ST series concealed hinges' snap-on mechanism improved

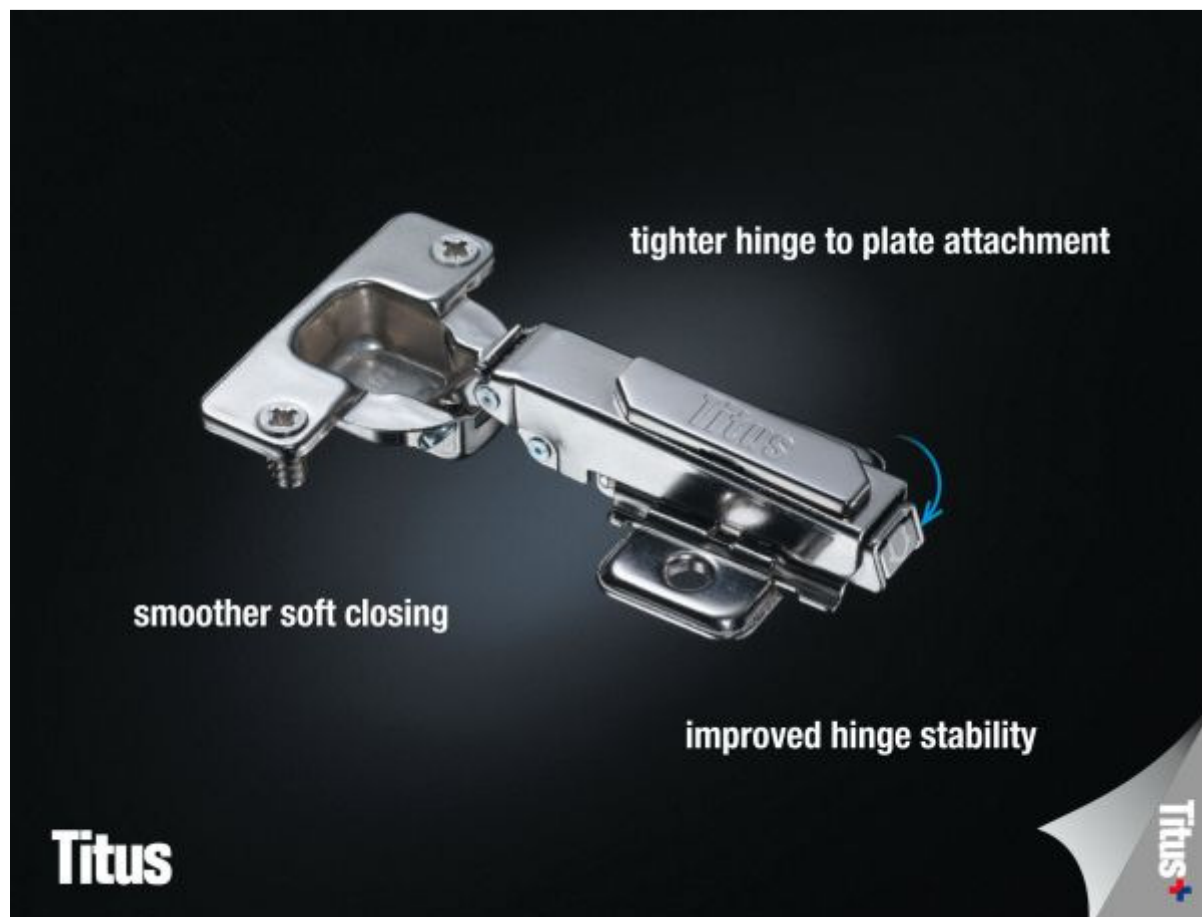
The improved ST hinge snap-on mechanism ensures a firmer hinge to plate attachment and a more consistent life-long performance. The stiffer design with rotary locking action provides a tighter connection which enhances the hinge stability and prevents the door sag. The increased firmness also allows for a smoother soft closing action. The SafeLock function at the rear of the snap-on mechanism prevents accidental detachment of the door when the door is forced past the maximum opening angle.

The improvement is applied to the full range of ST series hinges and has no impact on the existing base plates and current drilling specification. [More >>](#)
